# **RESPONSE TO SUBMISSIONS REPORT**

90-102 Regent Street SSDA

**THE TRUST COMPANY (AUSTRALIA) LIMITED ATF  
WEE HUR REGENT TRUST**

1 March 2020

Figure 2 Noise Treatment Diagram

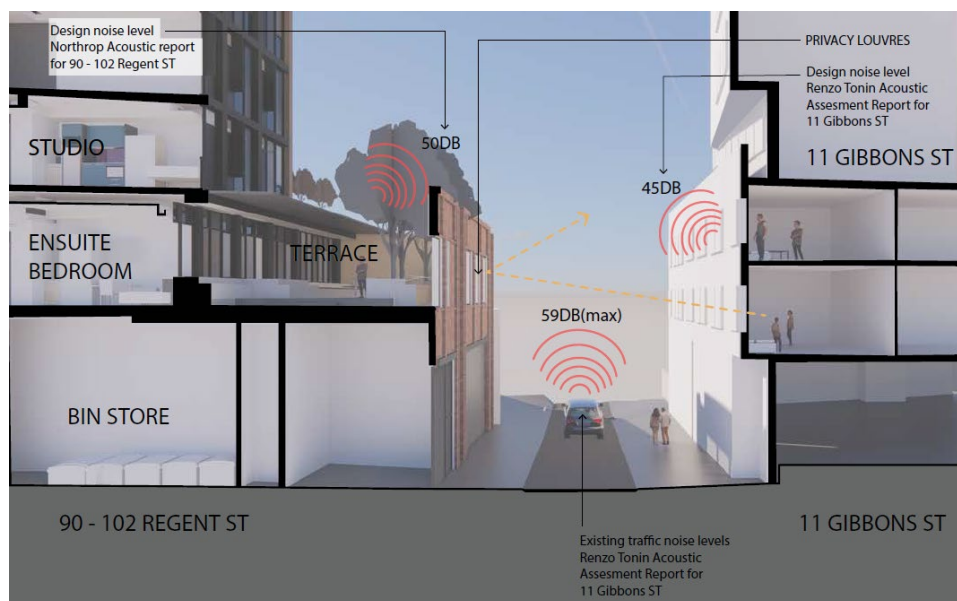
The outdoor cinema and music room was removed from the proposal to minimise the potential noise impacts and address the submission made by Iglu. The podium design incorporates enclosed glazed openings facing Marian Street to reduce noise impacts, as demonstrated in the following extract from the AJ+C Supplementary Design Report.
